SERVICE BULLETIN

Classification: EM18-002a	Reference: NTB19-006a	Date: September 11, 2019
------------------------------	--------------------------	-----------------------------

2015-2017 ALTIMA WITH 4-CYL ENGINE; EXHAUST LEAK FROM EXHAUST MANIFOLD

APPLIED VEHICLES: 2015-2017 Altima (L33)
APPLIED ENGINE: QR25DE (4-cyl)

Figure 1

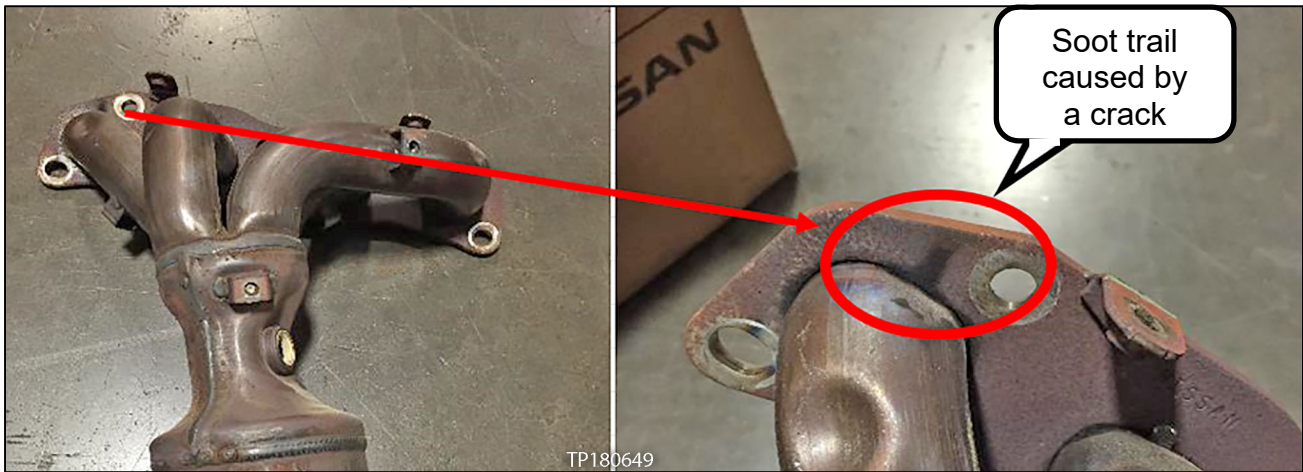
A crack is found in the exhaust manifold.

Example of an incident exhaust manifold (see Figure 1).

Replace the exhaust manifold and exhaust tube.

Figure 2

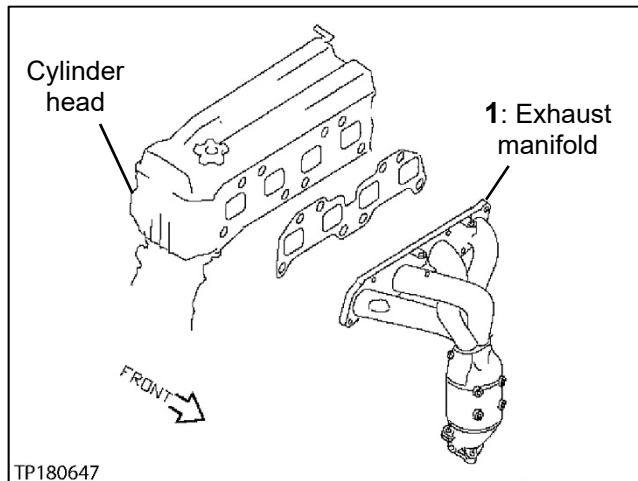
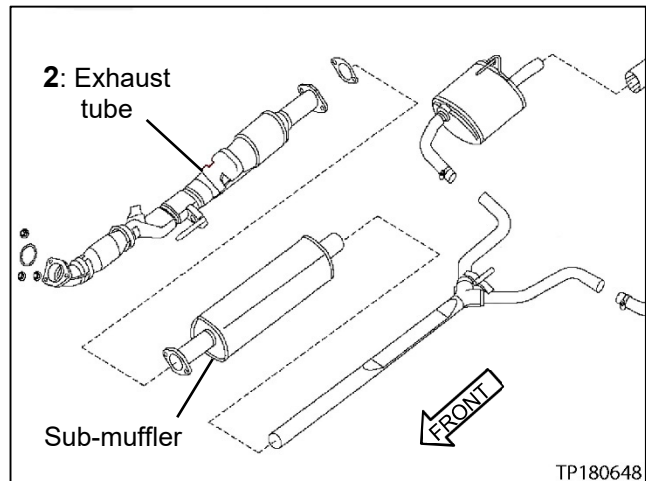
Replace parts 1 and 2 (see Figures 2 and 3).
